CITY OF MOSCOW COMMUNITY PLANNING AND DESIGN DEPARTMENT DEVELOPMENT REVIEW REPORT

Subject: Moscow Urban Renewal Agency request for redevelopment proposals for a parcel located at the southwest corner of the intersection of 6th Street and Jackson Street in Moscow, Idaho.

Applicant: Sixth and Jackson Development – Roderick Olps

Project Description: Roderick Olps is proposing a three-story 23,929 square foot mixed-use development. The proposal includes four adjoining buildings that contain six (6) commercial tenant spaces, one (1) commercial/café tenant space, and eight (8) enclosed parking bays on the ground level. The second and third levels contain a total of eight (8) 2-bedroom apartments and two (2) studio apartments.

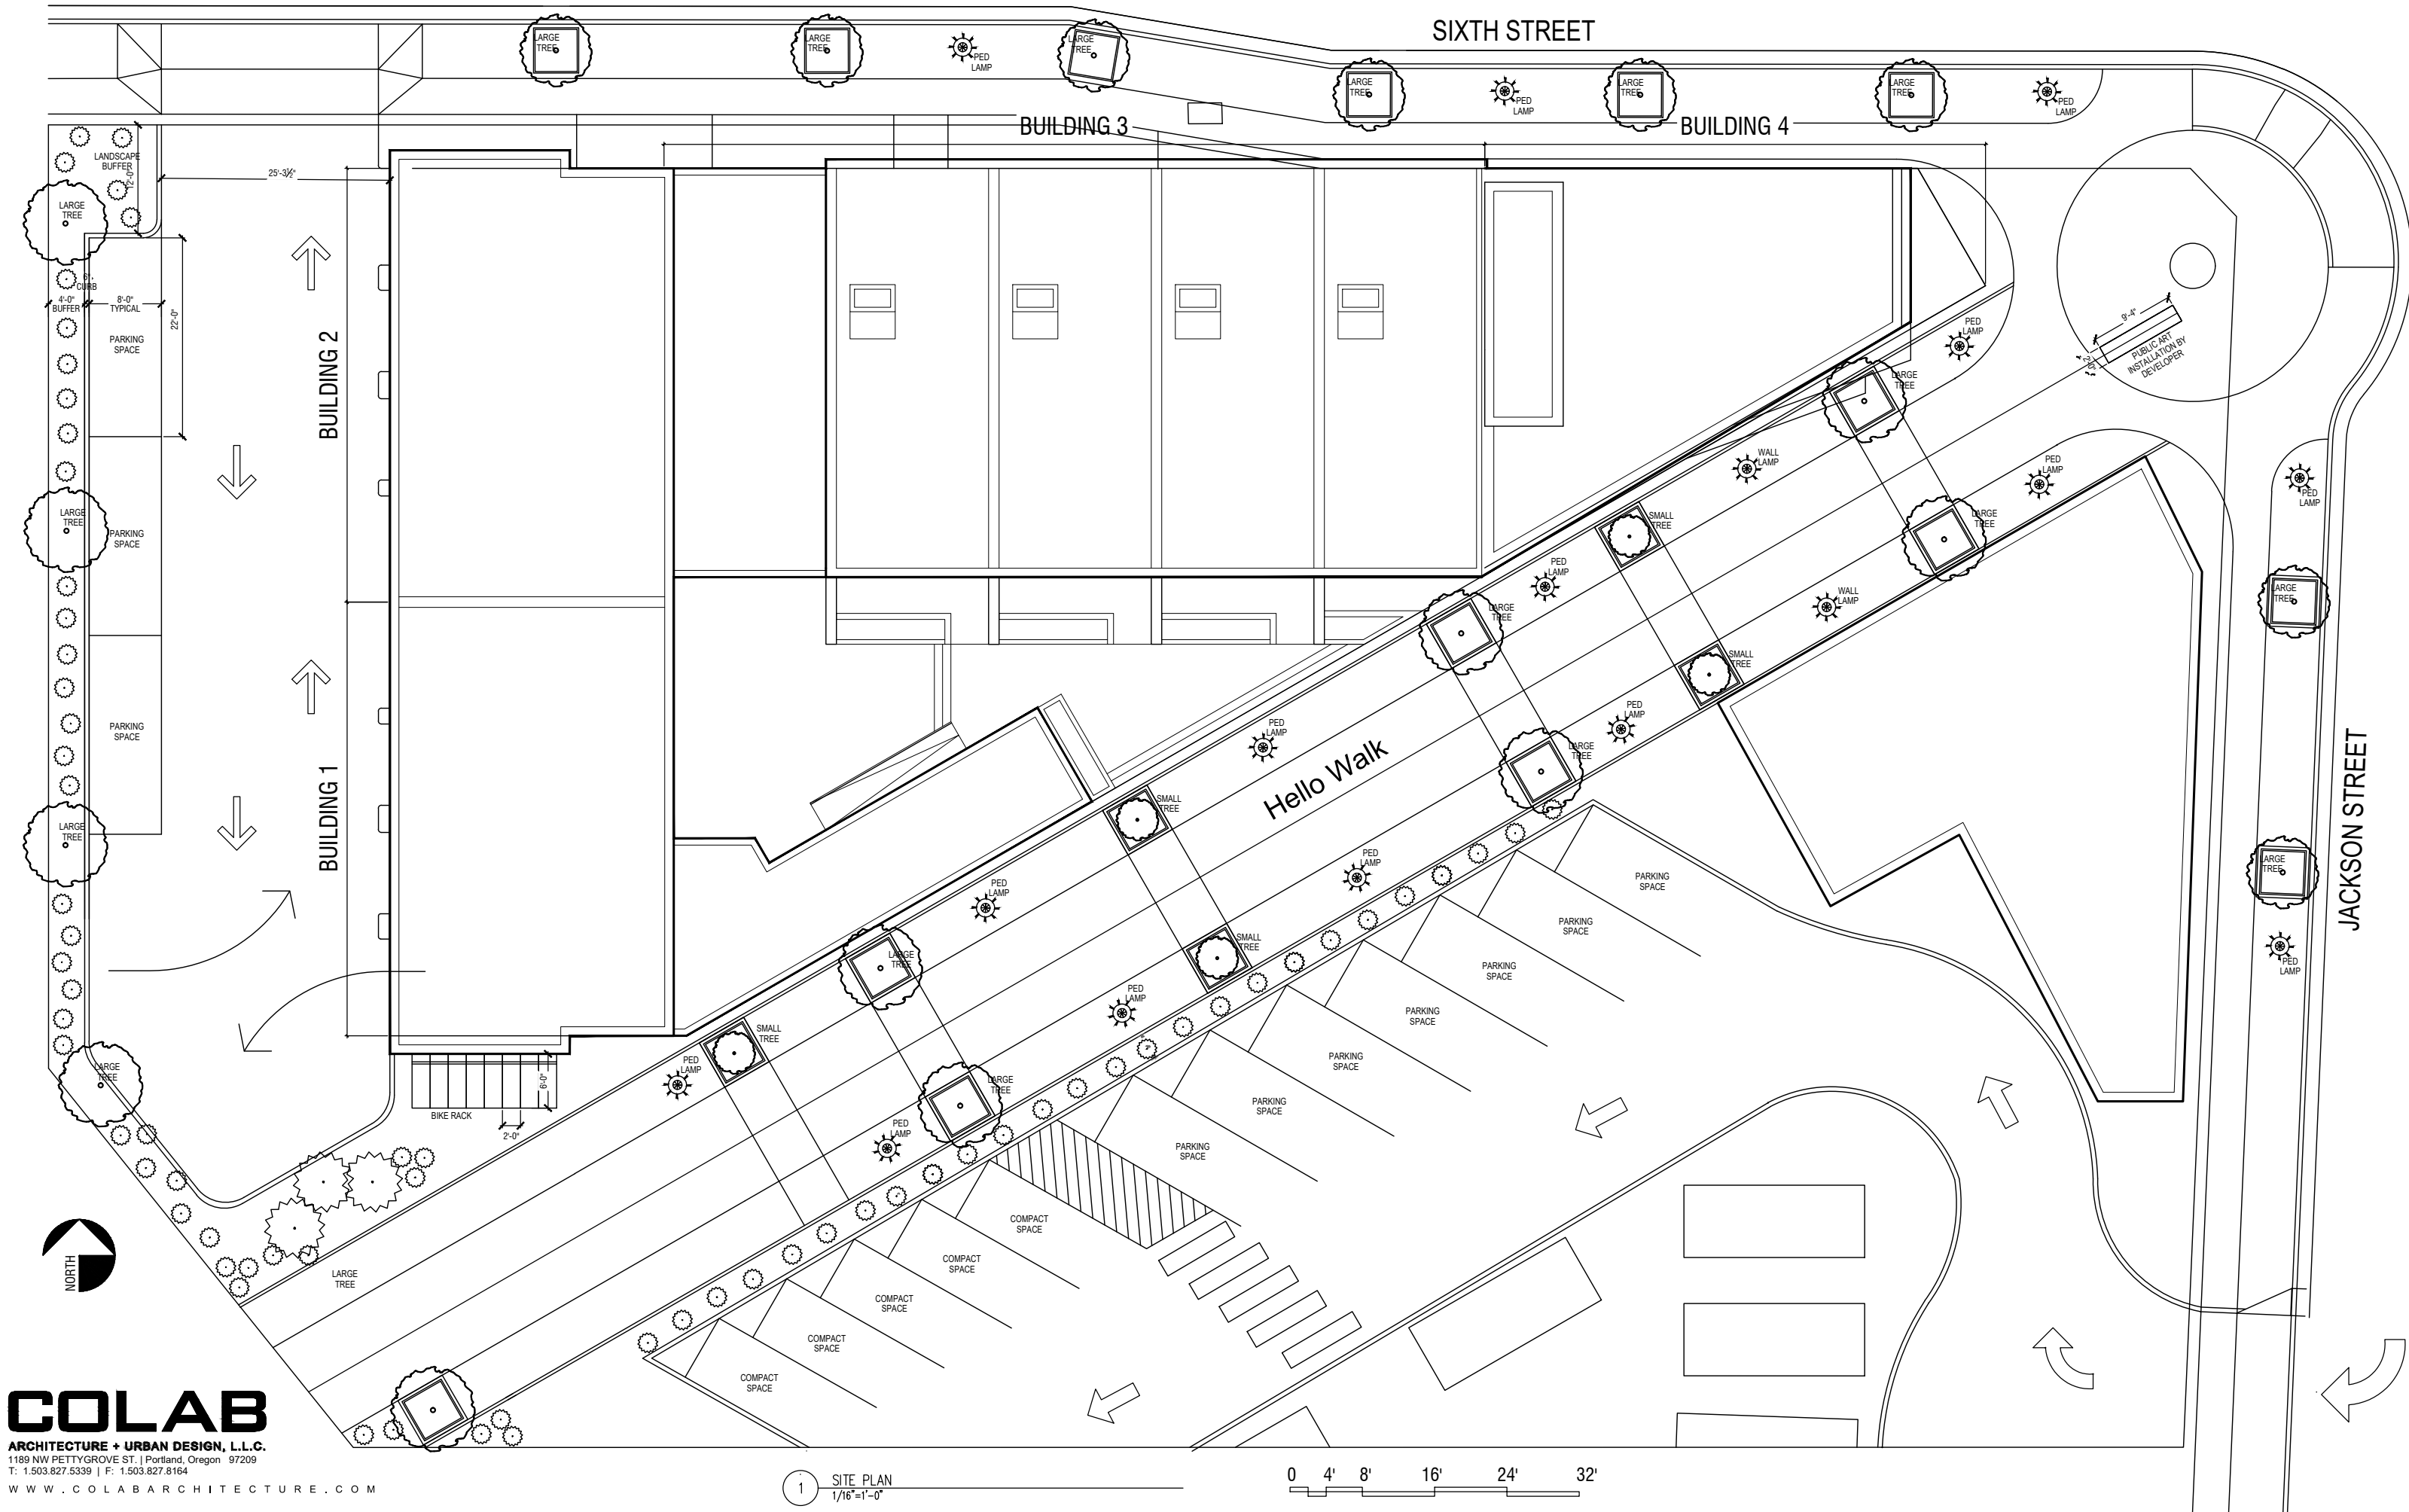
The placement of off-street parking and the landscaping surrounding the parking lot exceed the surface parking requirements of the code. The number of bicycle parking spaces does need to be increased from what is currently shown on the plans, which is 8, to the required 14 spaces. More detail will need to be provided to determine if the stormwater management provisions meet the intent of the guidelines. However, there is a green roof that has been incorporated into the single-story commercial building adjacent to Hello-Walk as well as planters dispersed throughout the development. Hello-Walk has been extended in accordance with the design guidelines and public art has been proposed in the existing circular plaza that serves as the entrance to Hello-Walk.

addition to meeting all other stormwater requirements and provisions of Moscow City Code		
Public Transit Facilities		
All developments within the LCO area should assess the need for transit facilities necessary to serve the development including the location of public transit stops, benches, shelters and signage.	NA	
Bicycle Parking Facilities		
Developments within the LCO area should provide bicycle parking for each use of a lot or structure in accordance with the standards found within Section 9.C.1	P	14 bicycle parking spaces are required and 8 are shown on the site plan.
Each bicycle parking space shall be sufficient to accommodate a bicycle at least six (6) feet in length and two (2) feet wide, and shall be provided with some form of stable frame permanently anchored to a foundation to which a bicycle frame and both wheels may be conveniently secured using a chain and padlock, locker, or other storage facilities which are convenient for storage and are reasonably secure from theft and vandalism.	Y	Bicycle spaces of the required dimensions are shown on the site plan.

6TH AND JACKSON - EXTERIOR ELEVATIONS

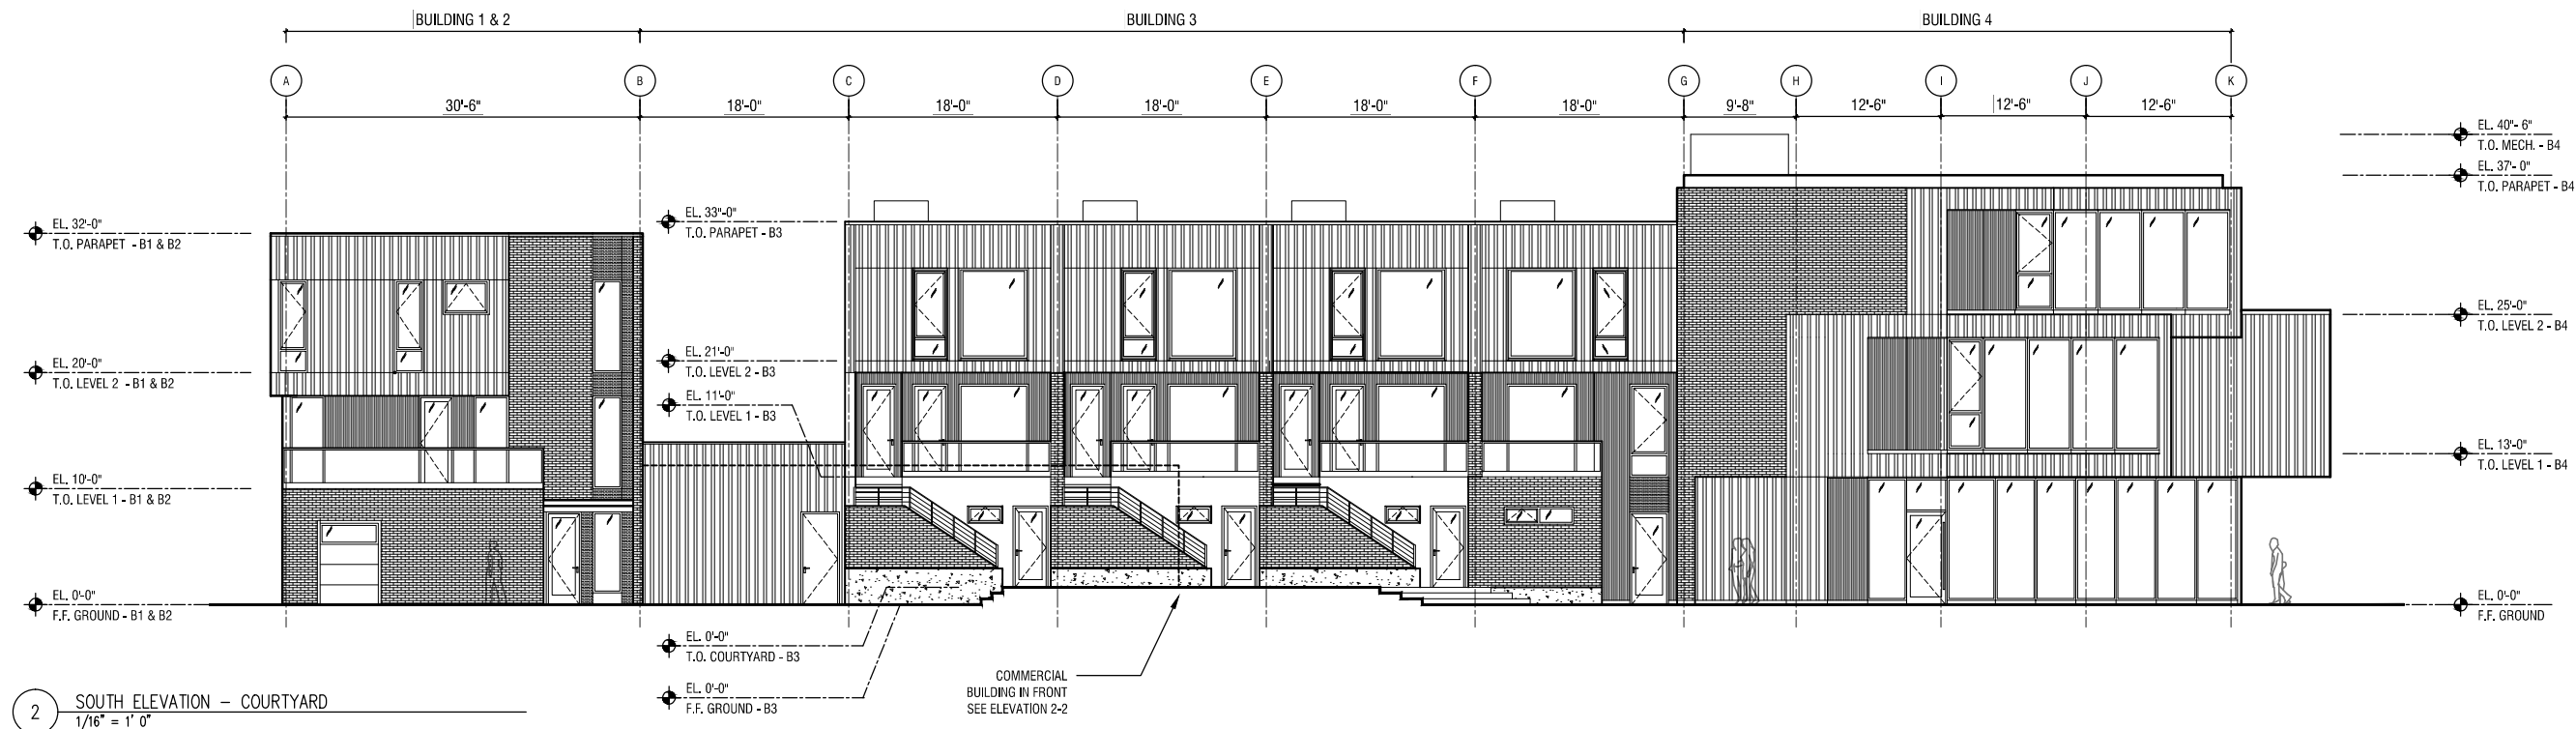
Summary: The proposed development complies with all of the requirements within the Legacy Crossing Overlay Design Guidelines document. The building placement and building height are all within the parameters dictated by the design guidelines. The proposed building complies with most of the building façade requirements which include front entry locations, façade design, the proportion of transparent window openings, and building materials. The only aspect of the building façade requirements that is deficient is the requirement that at least 75% of the façade width should contain projecting façade elements that provide shade and shelter to pedestrians when the facades are adjacent to public streets or pedestrian ways. The facades adjacent to Sixth Street and Hello-

Walk incorporate approximately 65% of projecting façade elements. Although the percentage of projecting façade elements is slightly less than is what is recommended in the design guidelines, Staff feels that the overall design of the project with numerous building projections meets the intent of the requirement.

Window Openings		
Fifty (50%) to eighty-five (85%) percent of ground-floor façades that front public streets and pedestrian ways should be occupied by windows and/or entry doors.	Y	Large transparent windows and doors occupy approximately 59% of the front facades (N, NE, E).
Windows and doors should utilize clear transparent glass in order to provide clear views of storefront displays from the street and to allow natural surveillance of the street and adjacent outdoor spaces.	Y	Transparent glass is proposed to be used for the windows and doors.
Mirror and tinted glass should be discouraged. Moderately tinted glass for energy conservation should be allowed.	Y	There is no proposed mirror or tinted glass.
For all floors above the ground floor, windows should occupy at least twenty (20%)	Y	The second-floor windows occupy approximately 25% of the total wall area.

of the total wall areas and should have a vertical orientation and proportion.		
Projecting Façade Elements		
Projecting façade elements should be in keeping with the historic architecture within the community including awnings and marquees.	Y	Brick masonry, solid concrete, and metal awnings are consistent with historical architecture within the downtown area.
Where buildings are adjacent to public streets or pedestrian ways, at least 75 percent of the façade width should contain projecting façade elements that provide shade and shelter to pedestrians	P	Approximately 65% of the façade widths adjacent to public streets or pedestrian ways contain metal awnings.
Façade Articulation		
Street facing building facades, as well as all facades that front a plaza or pedestrian way should be articulated to improve the quality of the design. Appropriate methods are described in Section 6.D.13	Y	The proposed building façades are articulated by increasing and varying the window openings; recessing windows and entryways; providing vertical and horizontal expression lines between the floors and around windows and doors; and adding depth and detail to each floor.
